**RE:** Proposed Dredging Modifications in Cut 10

This memo is in response to EPA requests for clarification provided in Stephanie Vaughn's September 27, 2013 email

EPA Comments and CPG's response

Figure 3 - Cross Sections Showing Location of Sediment Samples in Areas North of Station 31+00 (5 of 6)

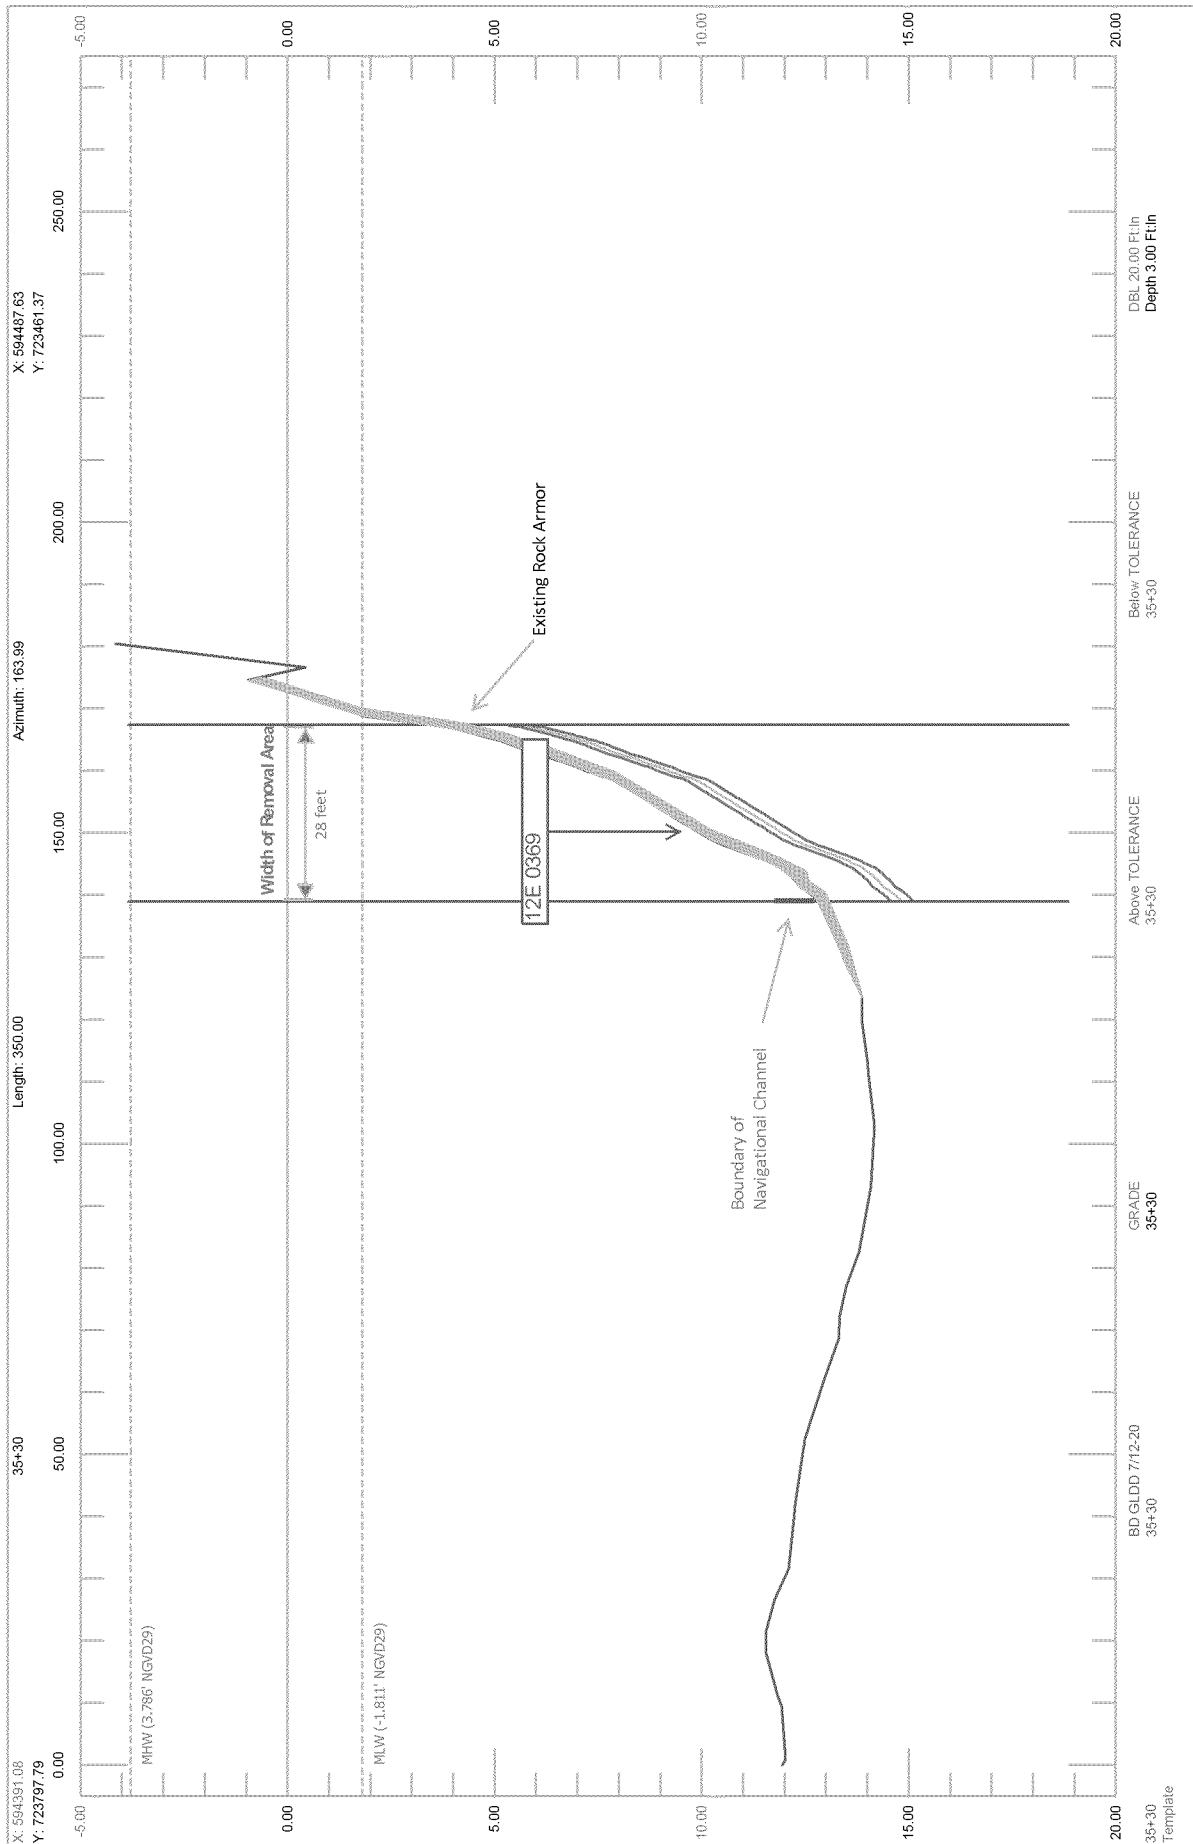
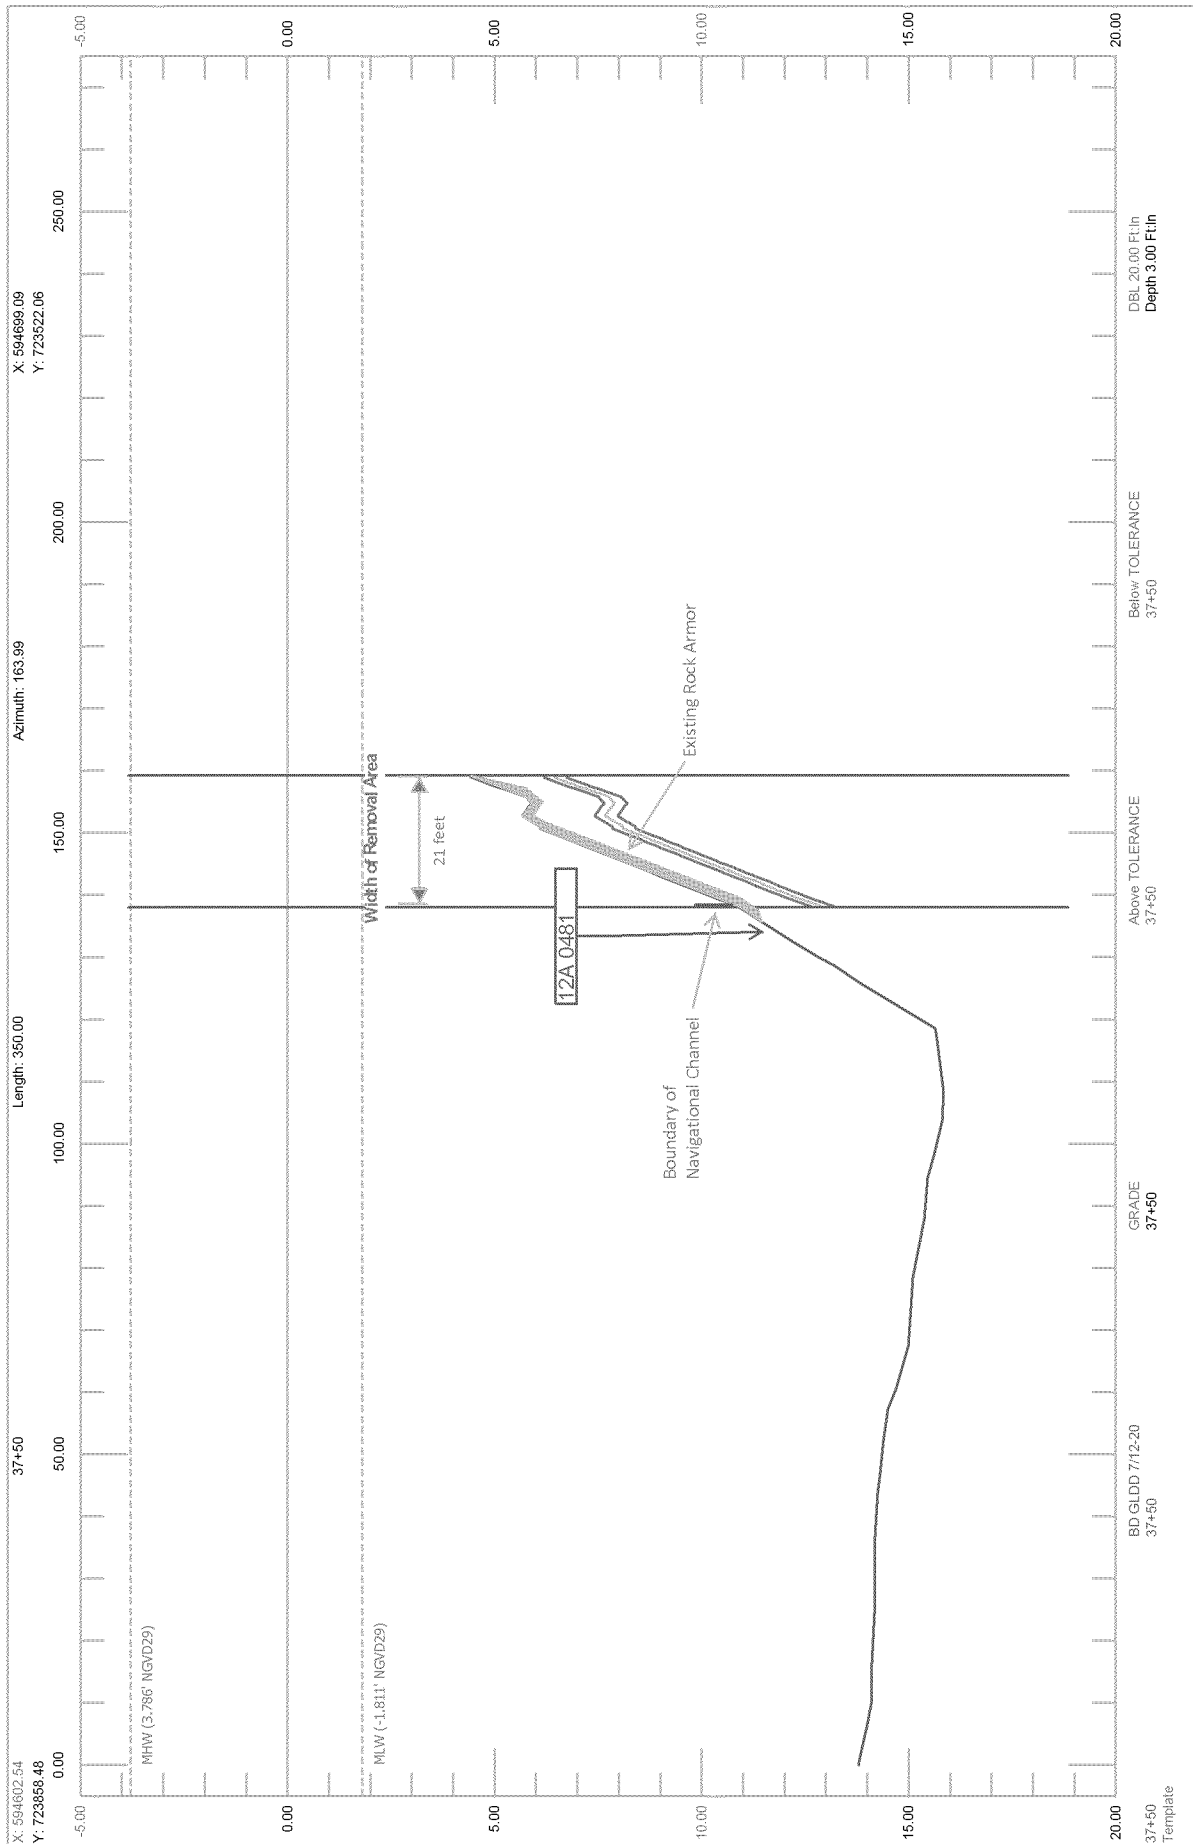
**2. *The width of the removal area is greater than 50' from Station 29+50 to Station 32+00, so at least some removal should be achievable in this area. After that, the width starts to trail off – but again, some removal should be achievable.***

- a. Dredging may be possible and will be attempted between Station 29+50 and Station 32+00 (which is beyond the area covered by the AOC). However, north of Station 32+00 the Removal Area narrows and the slope of bank increases to greater than 3:1, which is why the design indicated that this area could not be capped. The steep slope is the reason armor rock has been placed along this portion of the shore... to prevent potential erosion of the bank. This rock armor has been determined to extend to the toe of the slope, and the slope itself often extends to the boundary of the Navigational Channel.

- b. If there are areas where "dredgeable" sediment is present north of Station 32+00, CPG will attempt to dredge it provided that dredging will not remove the rock armor and destabilize the slope. However prior to that, CPG requests that EPA and/or CDM accompany the CPG's contractors on Monday afternoon to witness additional poling in those areas which, when combined with poling results obtained by GLDD on September 10 (see Attachment 1 which provides detailed findings from GLDD's previous poling in Cut 10), can form the basis for selecting the segments of Cut 10 where dredging could be attempted (see next section of this report for recommended poling and data interpretation procedures).
